Mechanical Services on the Champion House Site

Richard Redman
Campion Concerns October 2006

Appendix B. Plan of proposed semi-basement car park

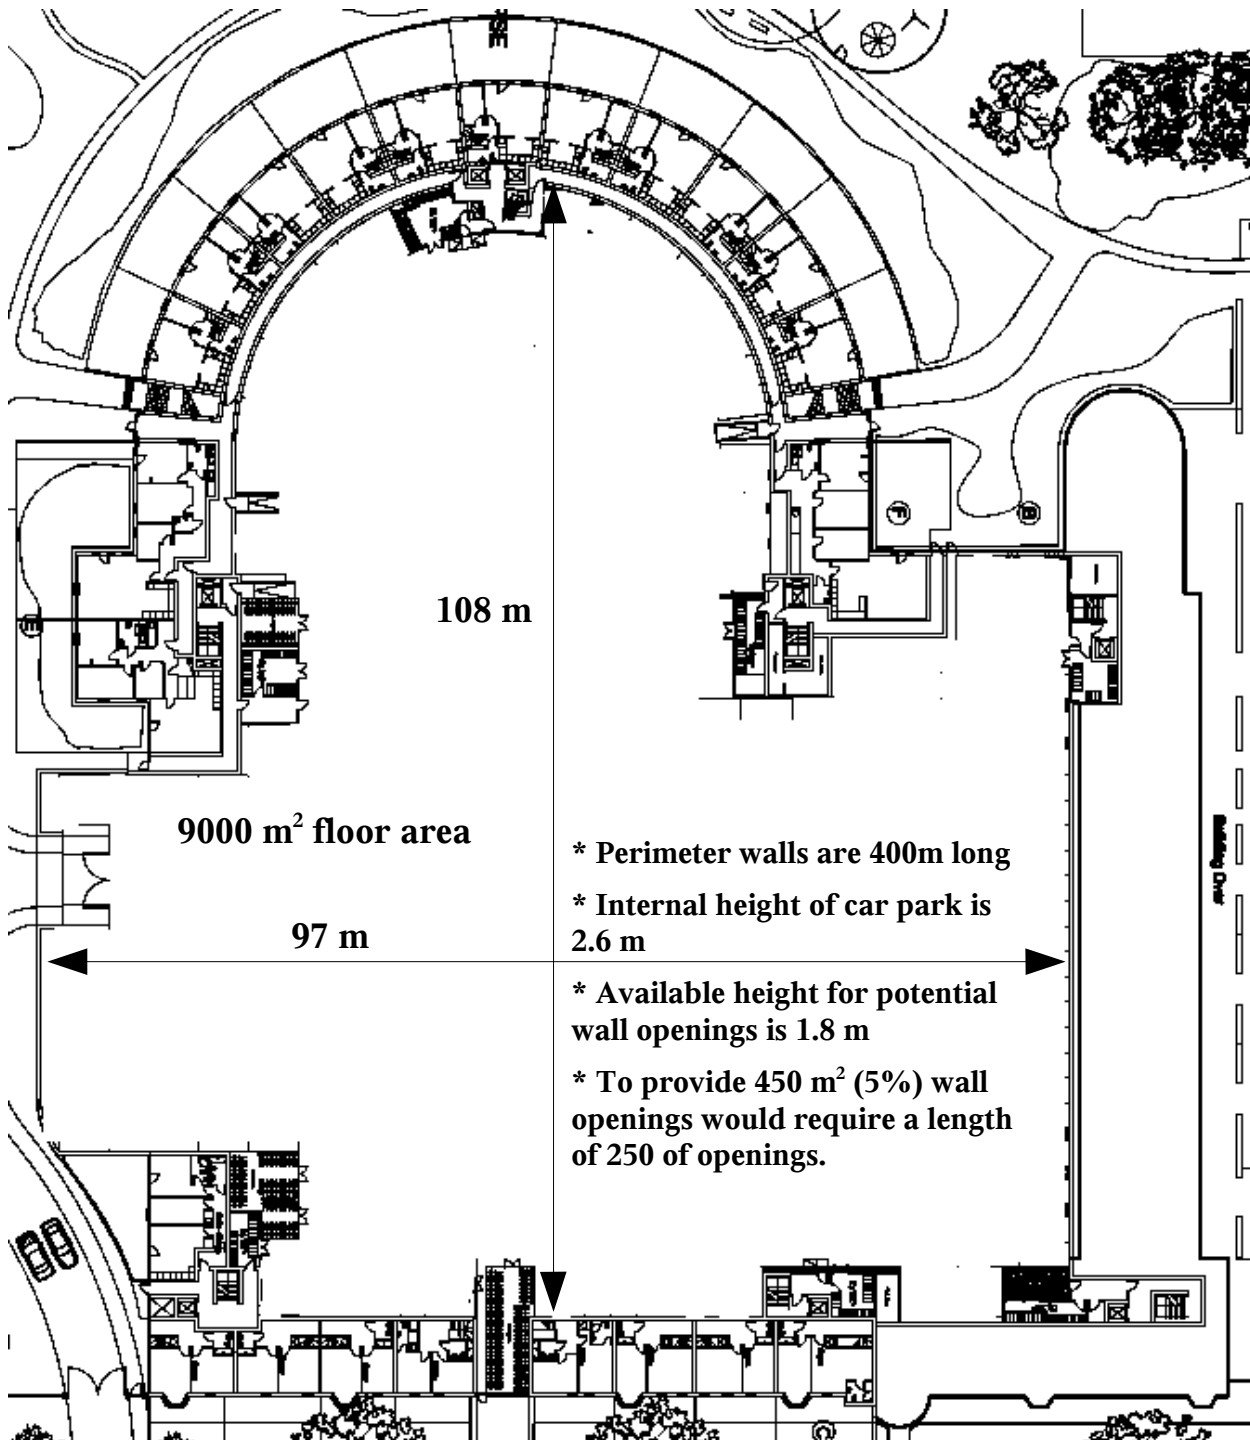
The lower ground floor plan (Architects drawings Nos 106, 110) shows that the internal car park is almost completely surrounded by flats, corridors and retaining walls. It would appear that natural ventilation is impossible as drawn.

As an illustration as to why natural ventilation cannot be achieved based on the application design, the car park has a floor area of 9000 m² and a height of 2.6 m. The perimeter of the internal car park wall is 400 m.

From this it follows that the openings required = 9000 x 0.05 = 450 m² of wall opening.

Assuming that the structural edge beam of the first floor (i.e. Car park ceiling, and a sill upstand from the floor might total 800 mm the net wall opening height would reduce from 2.6 m to 1.8 m. The total run of opening would therefore be

$$\frac{450 \text{ sq m opening required}}{1.8 \text{ m wall opening height}} = 250 \text{ m linear run (plus the width of the building support columns)}$$

This requirement of 250 m linear run is over 60% of the perimeter wall of the car park. If this were to be provided the lower ground floor flats would need to be omitted from the design.

The proposed car park is huge: 108 m front to Apse and 97 m, wide (entrance to wall below terraced houses). It is intended to contain 290 vehicles and is equivalent to two Osterley Station car parks. With so many vehicles carbon monoxide build-up, fuel odours could, dependent on wind and temperature, permeate to the flat corridors, stair-wells etc. and could (if wall openings were to be provided), cause fumes to rise and enter open windows of flats. This could also be a problem at the entrance at the exit/entrance ramp with numbers of vehicles, all with engines running, queuing to leave onto Thornbury Road traffic, or to enter the car park. This could cause a particularly excessive concentration of fumes.

If natural ventilation will not suffice then mechanical extract ventilation will be needed. This would require vertical ducts at intervals in the car park, at the centre, at surrounding walls and at the main entry (two thirds extract at low level and one third extract at high level). The ventilation system would create negative pressure at the wall openings with a duct to discharge to the roof. This would seem to us to make the semi-basement car park unviable.

It is not only important that an adequate area of ventilation openings is provided but also that these openings should be evenly distributed on opposite walls to allow for full ventilation of the entire area. We cannot see how this would be possible with the proposed design. If it is not possible then some areas of the car park would be likely to be 'dead spots' for ventilation.

Note. To provide a mechanical ventilation system instead of a non-mechanical/natural ventilation system, and assuming 6 air changes per hour, would require plant and ductwork handling about 40 m³ per sec. This is a considerable air volume requiring large and potentially noisy machinery. The requisite consumption of electricity would add to the non-sustainability of the development.
